**2 Meadow Road,
Ashmole Estate,
Lambeth, London,
SW8 1QB**

S73 application for minor changes
to Approved scheme 19/00744/FUL
and additional units

Oct 2025

Elevation Treatment

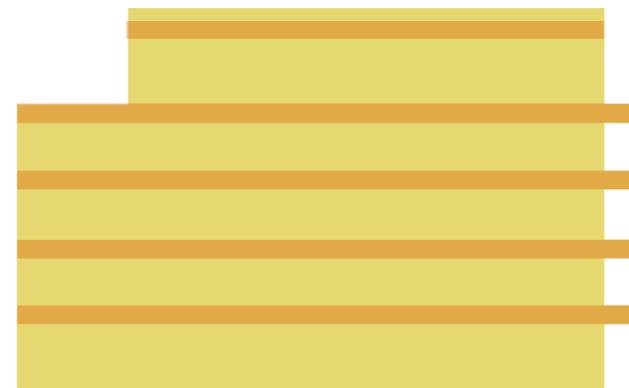
The proposed scheme changes the amount and proportion of corbelled brick detailing used across the facades. These changes were made following analysis of the materials, construction detailing and geometry of the proposed facades

- New choice of brick - the red multi bricks chosen bring a variation of colour and texture to the facade without relying on detailing
- The arrangement of balconies and brick panels on the south and east elevations is a strong geometric feature that does not need further embellishment. It is felt that the pattern of brick panel and openings provides a strong visual element without extensive decorative brickwork
- The approved scheme facade reads as a series of horizontals, making the building seem broader and longer. The introduction of brick movement joints needed for construction of the inset balconies means the building would be better suited to being read as a series of verticals. Therefore, the areas of corbelled brickwork have been amended to emphasise the vertical and draw the eye upwards.

Roof terrace

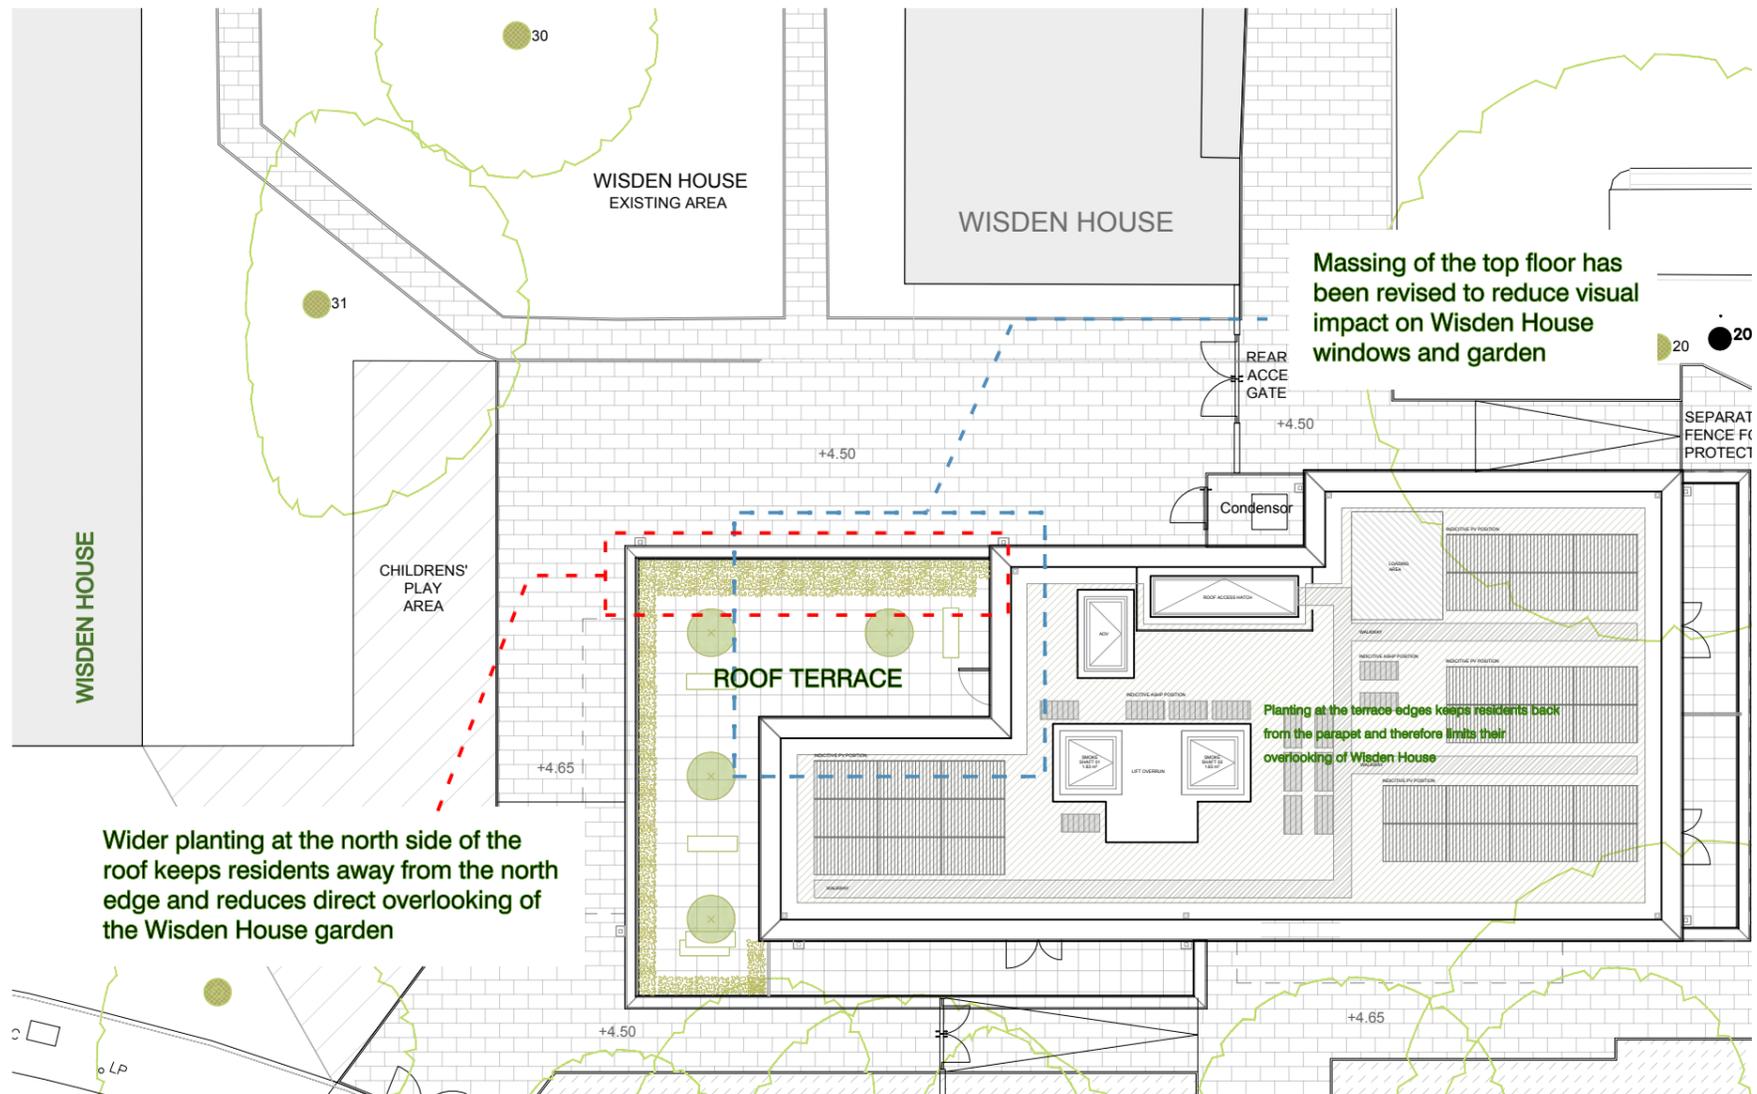
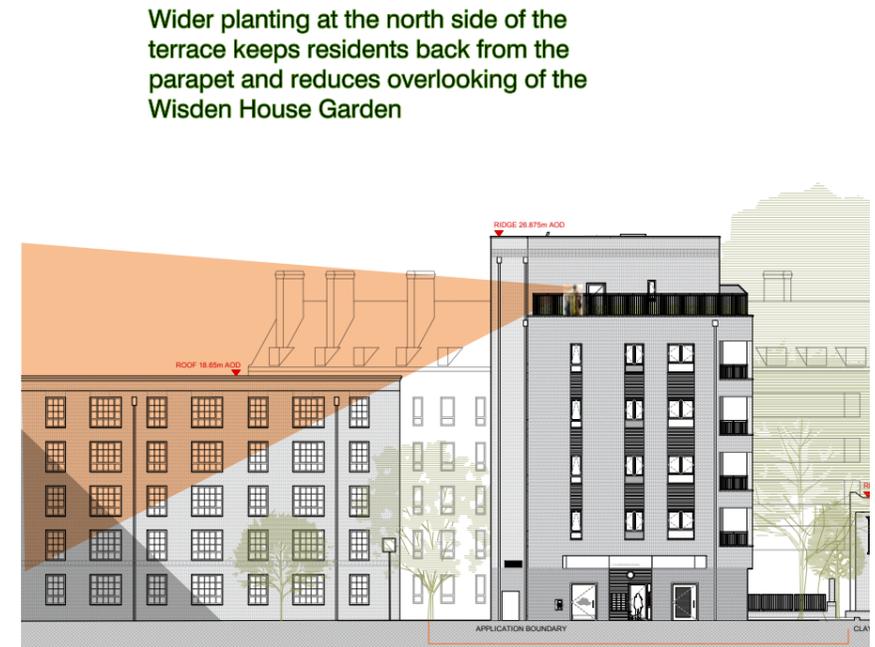
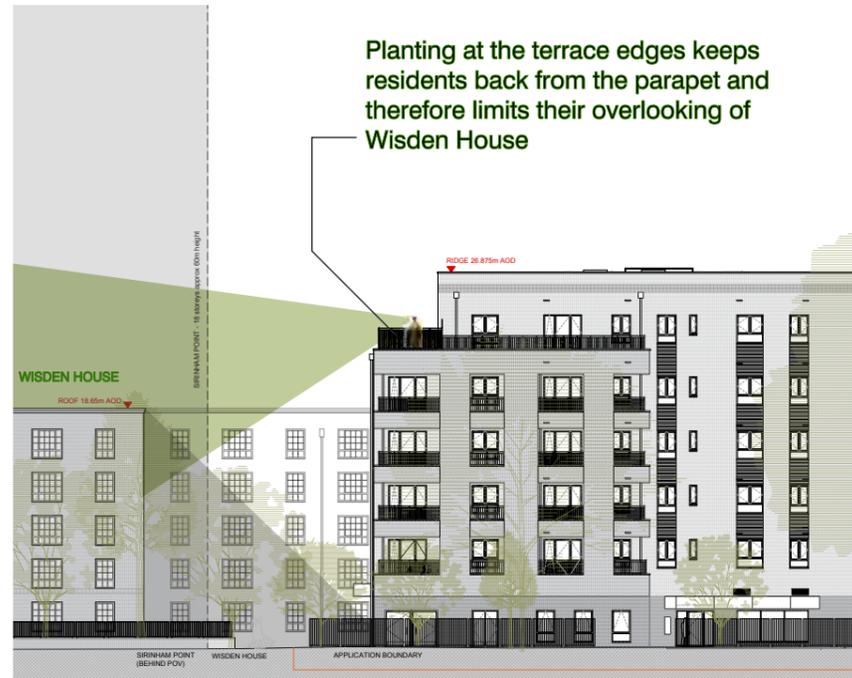
The revised building is slightly longer and therefore 1.4m closer to the elevation of Wisden House

The roof terrace has been raised from fourth floor to fifth floor, so the angle of view from the terrace to Wisden House has been made more acute, which reduces the opportunity for overlooking.

As with the approved version planting around the perimeter of the roof terrace can be used to control the openness of views to and from the terrace, discouraging views north west into the garden in front of Wisden House. Making the planting wider to the north of the roof also reduces overlooking of Wisden House and its garden
